Drawing Change Notice

CHANGE DOCUMENT NO.
24590-BOF-M6N-DEP-
00001

JOB NO. 24590	TITLE FOR CHANGE NOTICE MISCELLANEOUS CHANGES TO LOW POINT DRAIN VESSEL P&ID		
DOCUMENT NUMBER		REV	DOCUMENT NUMBER
24590-BOF-M6-DEP-00001002		0

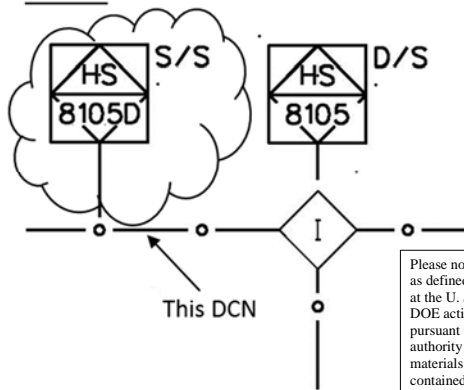
- 1) Add software switch DEP-HS-8105D to start/stop pumps in zone G6 of 24590-BOF-M6-DEP-00001002

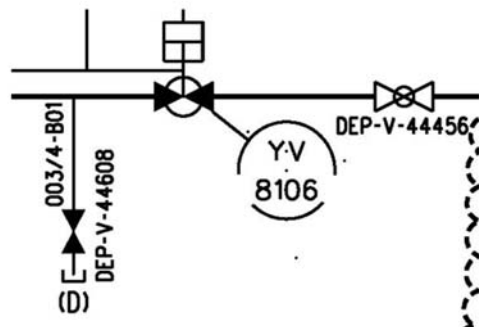
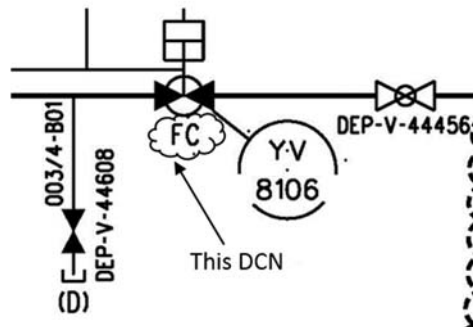
- 2) Add fail close label to valve DEP-YV-8106 found in zone G4 of 24590-BOF-M6-DEP-00001002

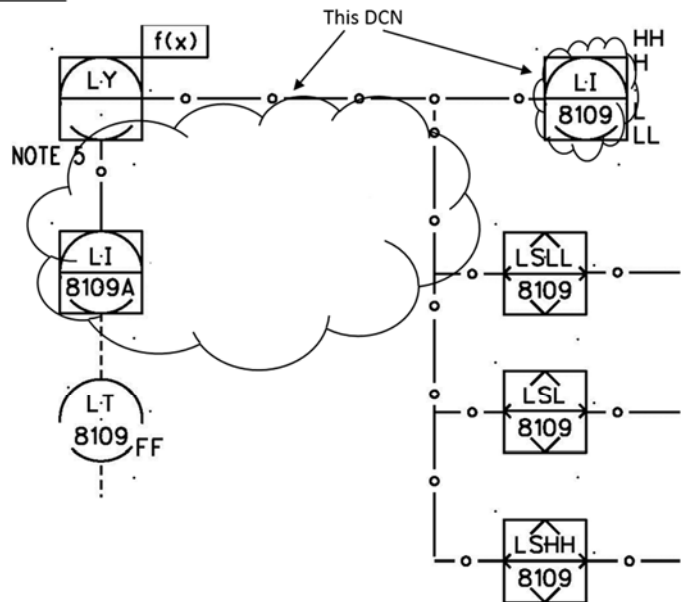
3) Switch tag numbers of level indicators and change source of data signals found in zone E3/E4/F3/F4 of 24590-BOF-M6-DEP-00001002

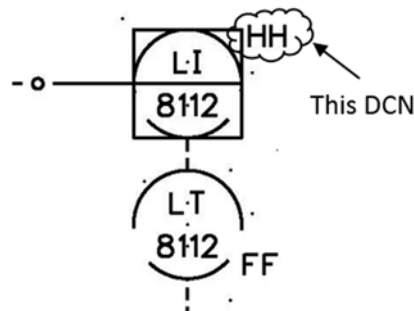
5) Add high-high alarm to level indication DEP-LI-8112 found in zone C3 of 24590-BOF-M6-DEP-00001002
